WATER RESOURCES DEPARTMENT

PUBLIC INTEREST REVIEW FOR GROUNDWATER APPLICATIONS

SUBJECT: Application G- **18256** Supersedes review of **na**
Date of Review(s)

A. GENERAL INFORMATION: Applicant's Name: **City of Independence** County: **Polk**

Water-Level Trends in Nearby Wells

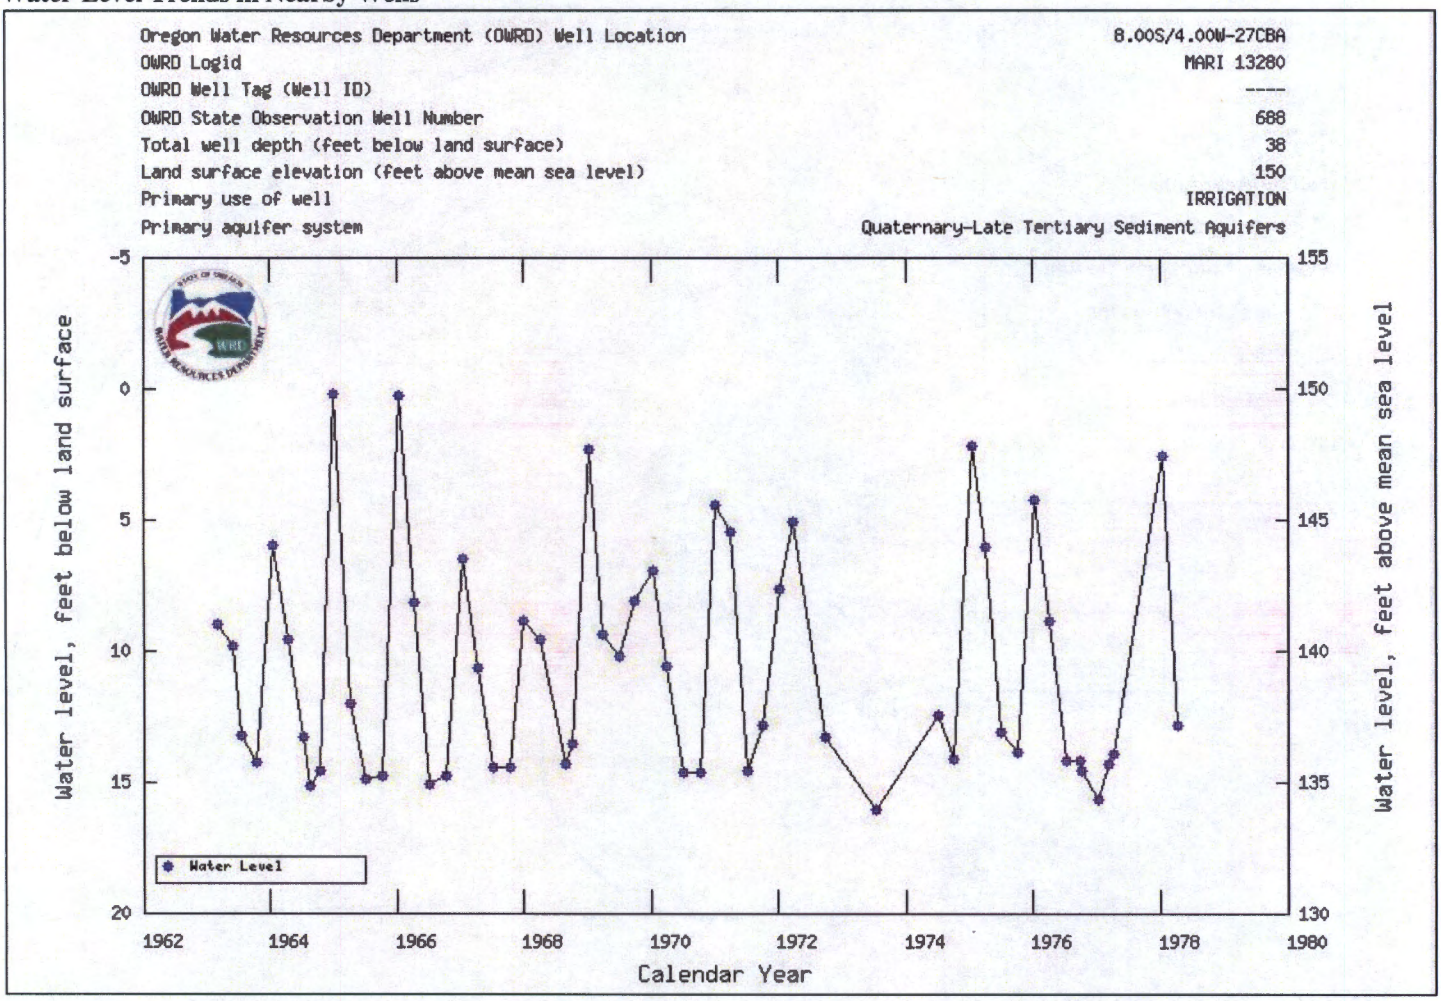
There are no nearby wells with long term hydrographs extending to present time. A well (MARI 13280), located approximately 1 miles to the southeast across the Willamette River, has water level data from the early 1960's through the late 1970's. The hydrograph for MARI 13280 shows no decline.

Transient Stream Depletion

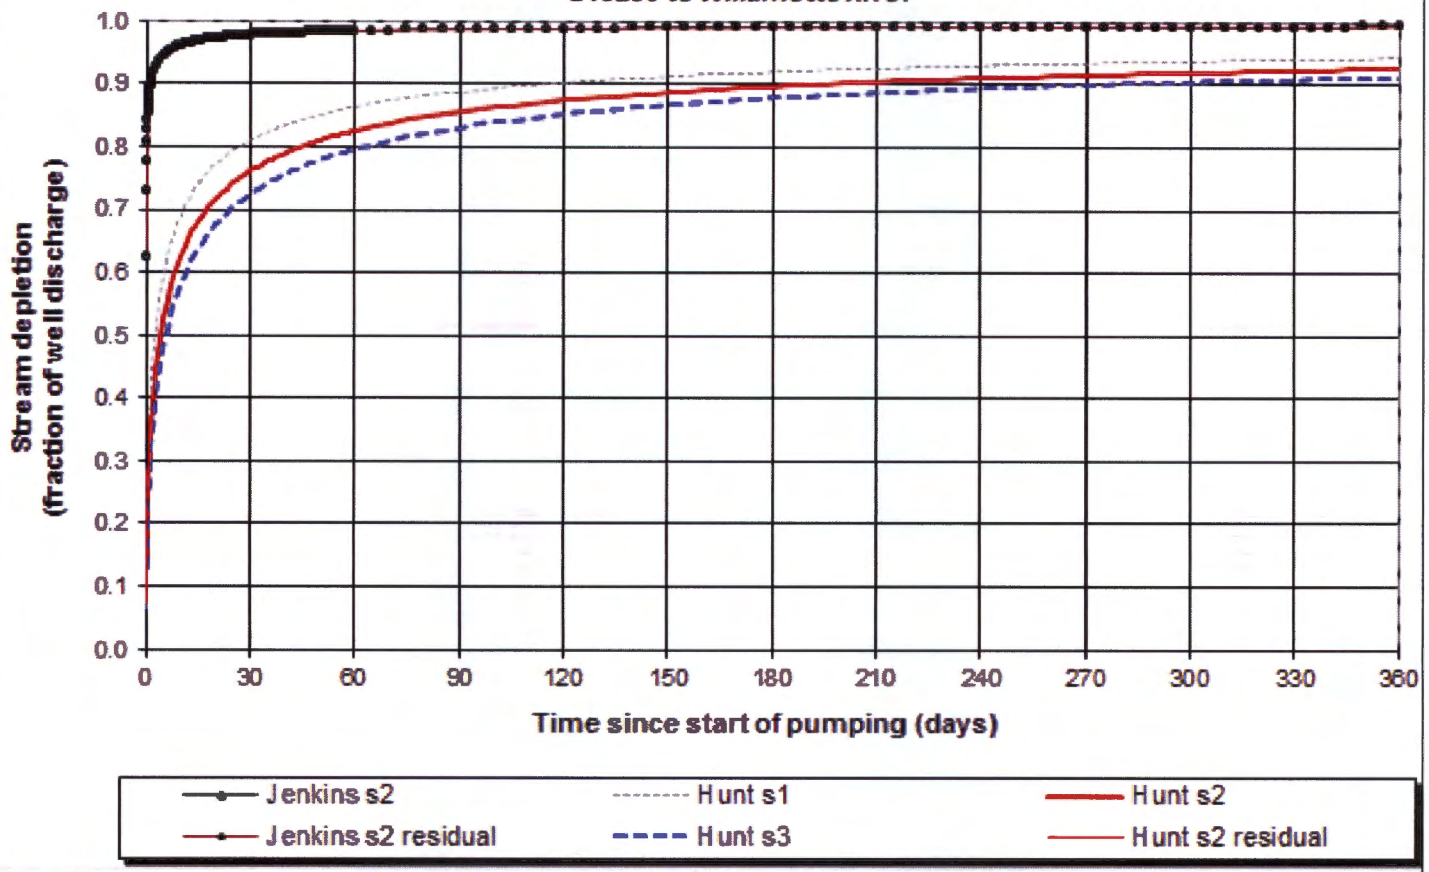
Comments: The interference at 30 days was estimated using the Hunt 1999 model (unconfined aquifer with a streambed clogging layer) and assuming a 3 foot streambed clogging layer. A transmissivity value range from 30,000 – 90,000 ft^2/day was estimated based on single well pump tests from nearby wells which are similarly located in the meander belt/flood deposits of the Willamette River (POLK 3713 located ~4.2 miles to the southeast and POLK 3714 located ~4.4 miles to the southeast)
